# Technical Service Bulletin

**NUMBER:** 18-013-01

Rough Idle at Cold Temperatures

This bulletin involves selectively erasing and reprogramming the Powertrain Control Module (PCM) with new software (Cal level 00Cal15C.).

**FIGURE 1 - AUTHORIZED SOFTWARE UPDATE LABEL**

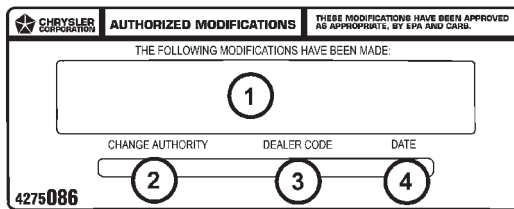
- 7. Type the necessary information on the “Authorized Software Update Label” p/n 04669020 (Figure 1). Attach the label to the PCM and cover the label with the clear plastic overlay.
